BID BULLETIN

Project Name: ***Repair and Renovation of University Library Roof, Ground Floor, Second Floor and Third Floor with Provisions for Furniture and Fixtures (ABC: PHP 10,886,963.56)***

The Bid Bulletin is issued to modify and/or amend items in the Invitation to Bid and Bidding documents. Please take note of the clarifications for the Project.

SECOND FLOOR REFLECTED CEILING PLAN
SCALE: 1:125mtrs

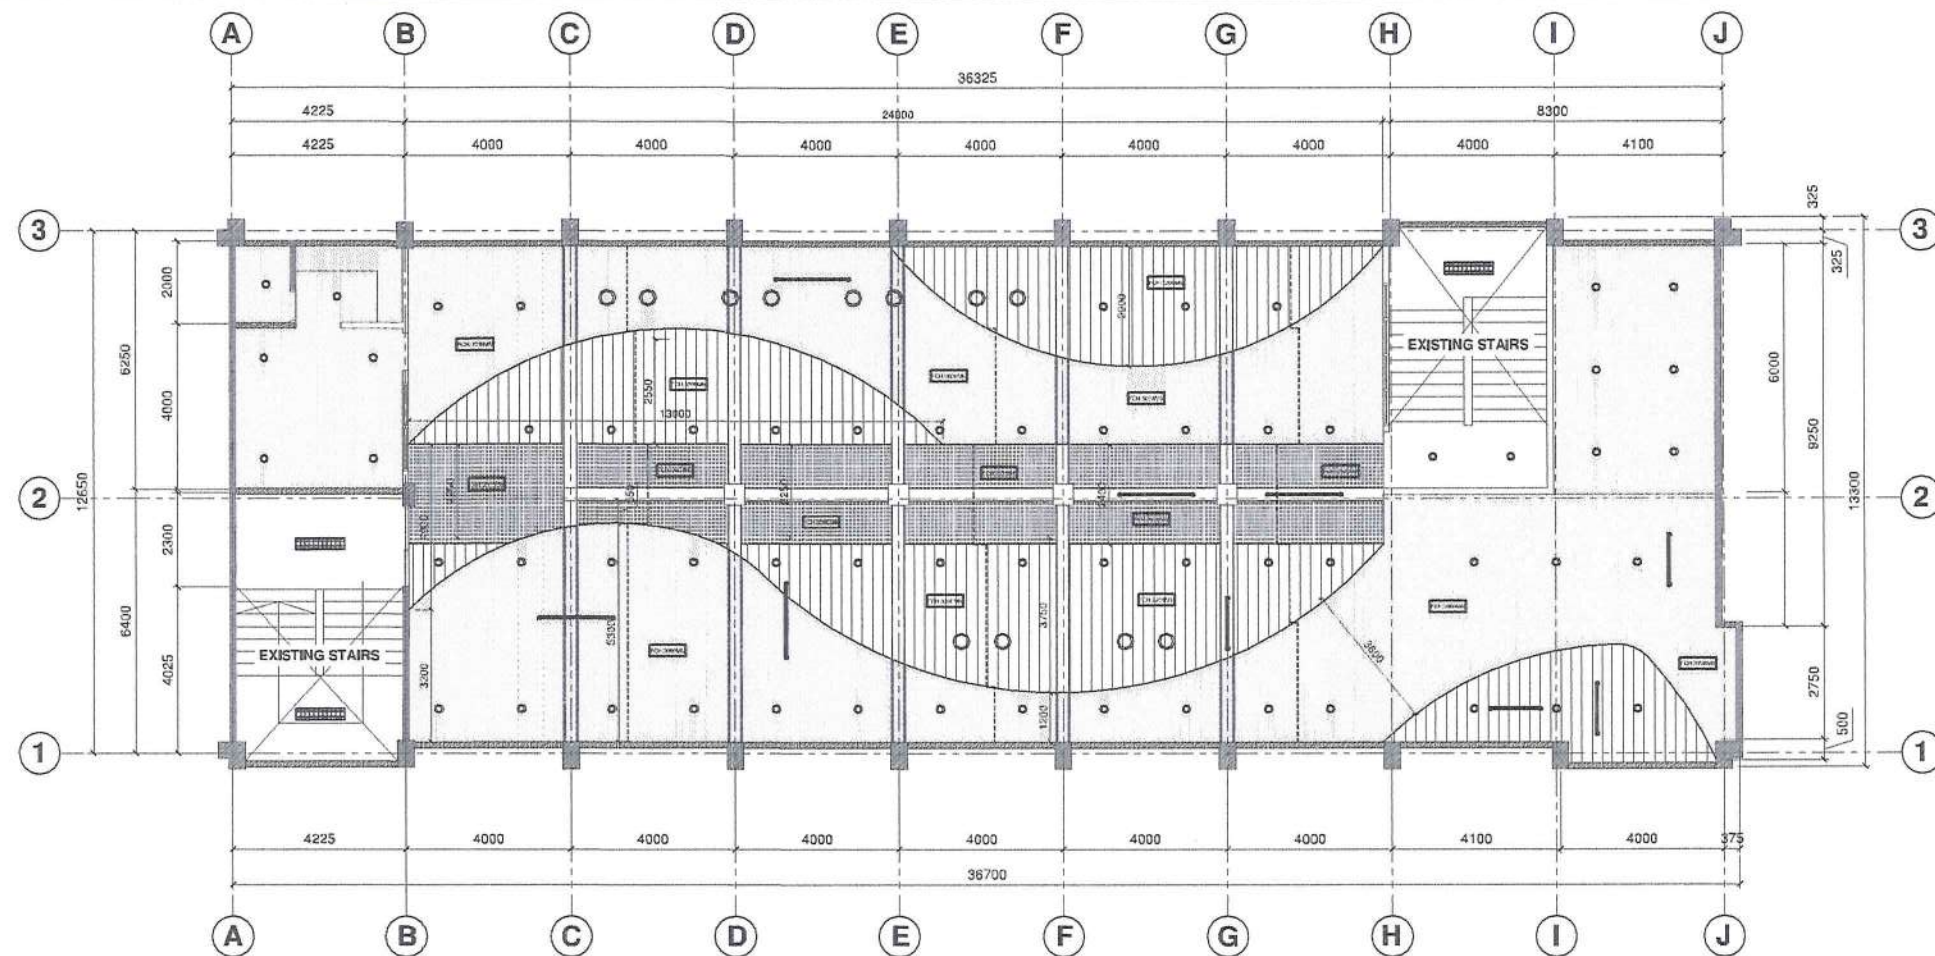
- Sheet# A06 of the drawing plans is modified to show the inclusion of the **Second and Third Floor Tile Layout**. *Please see attached amended Sheet# A06*
- Sheet# A09 and A#10 of the drawing plans is modified to show **Legends**: for guidance and reference. *Please see attached amended Sheet# A09 & A10*
- In Section III. Bid Data Sheet ITB Clause 10.4 List of Key personnel, inclusion of an **Electrical Engineer** with General and Relevant Work Experience of 5 years.
